June 1, 2023

Subject: PA-2022-099 1855 S. Norfolk St., SUP + SPAR + SDPA
1885 S. Norfolk St., APN 035-383-200

Planning Comments:**1. Planning Application Guide Submittal Requirements**

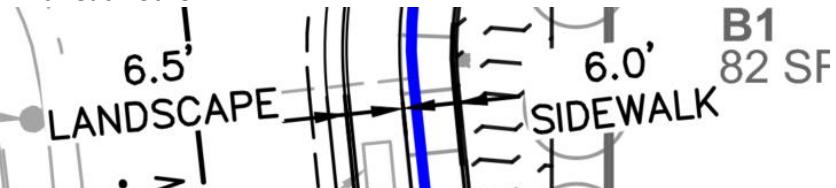
<input type="checkbox"/>	SITE PLAN. (No smaller than 1/8" scale or 10' scale). Drawn to scale and showing the following:
	<ul style="list-style-type: none"> • All dimensioned property lines consistent with County Assessor's Parcel Map or Site Survey. • Adjacent streets drawn and dimensioned to the centerline of the street, showing sidewalks or curb line. Label the distance between the back of the sidewalk or curb and the property line. <ul style="list-style-type: none"> ○ Please label the distance between the back of the sidewalk or curb and the property line on all street frontages. <ul style="list-style-type: none"> ▪ Cycle 2 – The distance between the back of the curb and the property lines is still not clearly labeled. Please see staff's estimated measurements in red below.

S. Norfolk St. and Fashion Island Blvd.

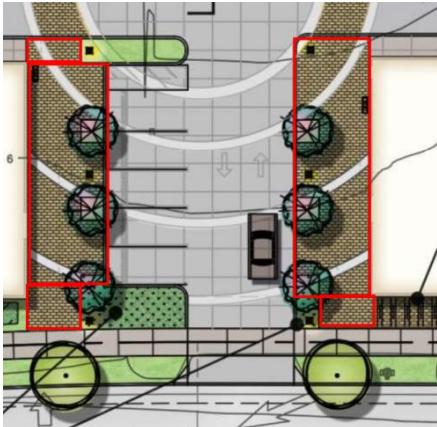
- Please update the arrows provided for the 4.5ft. landscape strip and the 5ft. sidewalk shown along S. Norfolk St. and Susan Ct. Currently it is not clear where each begins and ends since the arrows seem to overlap.

- **Cycle 2** – Comment still stands. The arrows provided below still conflict with each other.

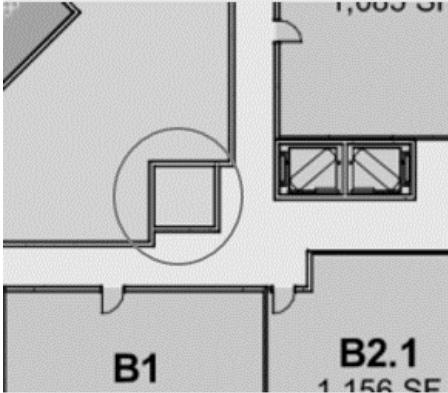
- **Cycle 2** – Please clearly indicate and provide additional details for the treatment of the area beyond the perimeter trees, along and underneath the Fashion Blvd. overpass.
- Please label and dimension the paved walkways on each side of the driveway.
 - **Cycle 2** – Comment still stands. Please provide the dimensions of the accent vehicle/ pedestrian paving on both sides of the uncovered parking.

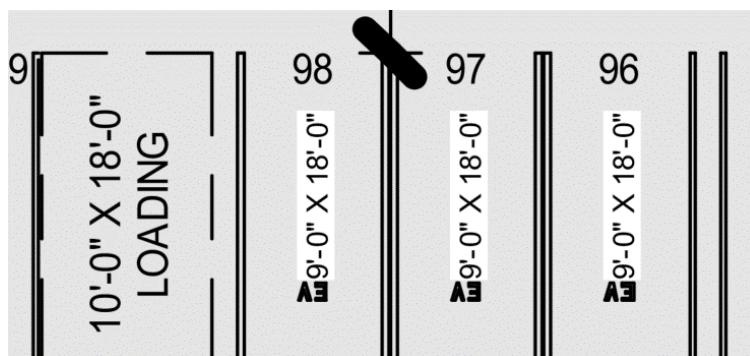
<input type="checkbox"/>	FLOOR PLANS (1/4" scale preferred). Drawn to scale and showing the following:
<ul style="list-style-type: none"> ● Proposed floor plans. <ul style="list-style-type: none"> ○ Please provide a legend that corresponds to the colors on the floor plans to identify the proposed use for each space. ● Overall exterior dimensions and individual room dimensions for all levels and stories. <ul style="list-style-type: none"> ○ Please provide overall exterior dimensions of all floors. ○ Please provide enlarged unit plans for each plan type. <ul style="list-style-type: none"> ▪ Cycle 2 – There are only 5 unit plans shown on sheet AP4.00; however, 13 unit types are listed in the project information tables on sheet AP0.00. Please provide unit plans for each type of unit. ▪ Cycle 2 – Please provide typical room dimensions on unit plans. ● On sheet AP0.03, please provide a breakdown of units by floor for each building. ● Location of all doors and windows, including window sizes. <ul style="list-style-type: none"> ○ Please show and dimension all window and door openings on the floor plans. <ul style="list-style-type: none"> ▪ Cycle 2 – The unit plans do not show openings for windows. Please dimension and show the windows in each unit plan. The windows shall correspond with the window placement on the proposed elevations. ○ Please see the <i>Design Comments</i> section for information of natural light in the residential corridors. ● Please identify the proposed use(s) that occur on the roof deck. In particular, there is an unlabeled room on the roof deck. Unless exempted by SMMC 27.02.060, rooftop uses such as storage or toilet rooms increase the plateline of the building. <ul style="list-style-type: none"> ○ Cycle 2 – Please provide a section detail of the penthouse. ● Please label all rooms on the floor plan of the North Building. Please see image below.
